QUALITY ASSURANCE -- NON-CONFORMANCE REPORT

Reference Description: Cuts Made on Lift 14E East Anchorage (SA) Vertical Plates Not Shown on Approved Shop Drawings

Subject: NCR No. ZPMC-0911

Job Name: SAS Superstructure

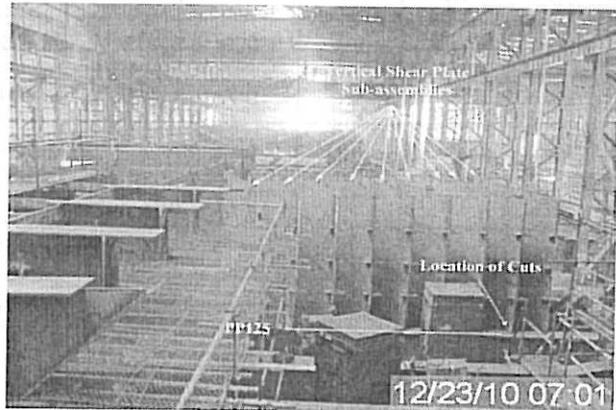
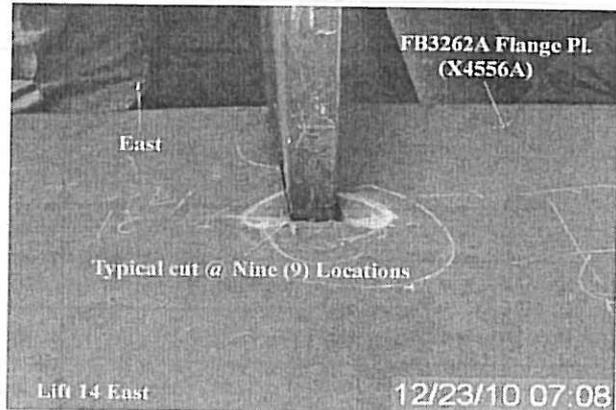
During the Quality Assurance (QA) random in-process observations of the fabrication of OBG segment 14E in fabrication Bay 14, this Caltrans QA Inspector observed the following issue:

- ZPMC personnel cut out the leading edge of the Vertical Shear Plate Sub-Assemblies (Web) in a total of nine (9) locations to facilitate fit up at the Panel Point 125 Floorbeam (FB3262A) slotted flange connection.
- Following the removal of the Shear Plate web material, ZPMC personnel have masked the roughly free hand cut area by welding it to the flange plate.
- The Vertical Shear Plate sub-assemblies are identified as SA3357A, SA3358A, SA3359A, SA3360A, SA3361A, SA3362A, SA3363A, SA3364A and SA3365A and are designated on the contract drawings as Seismic Performance Critical Members (SPCM).
- Maximum dimension of the Vertical Shear Plate web removal was 20mm deep and 40mm in length.
- Segment 14E is in the OBG Fabrication Bay 14.

See attached photographs for additional detail.

During the installation of EB anchorage shear plates, ZPMC had to cut a portion of the leading edge. As discussed with engineer, the proposal to taper the cutout with 1:10 transition and grind smooth the cut surface was accepted. All the remedial work as required has been completed. Based on this, ZPMC is requested closure of this NCR.

During the installation of EB anchorage shear plates, ZPMC had to cut a portion of the leading edge to clear the interference with PP125 FB flange. Please confirm if it is acceptable to taper the cutout with 1:10 transition and grind smooth the cut surface. No weld repair will be needed.

Contractor to carry out the retrofit work as per the TC-RFI which has been accepted.

ZPMC completed the retrofit as required in the TC-RFI and has been inspected and accepted by QA.
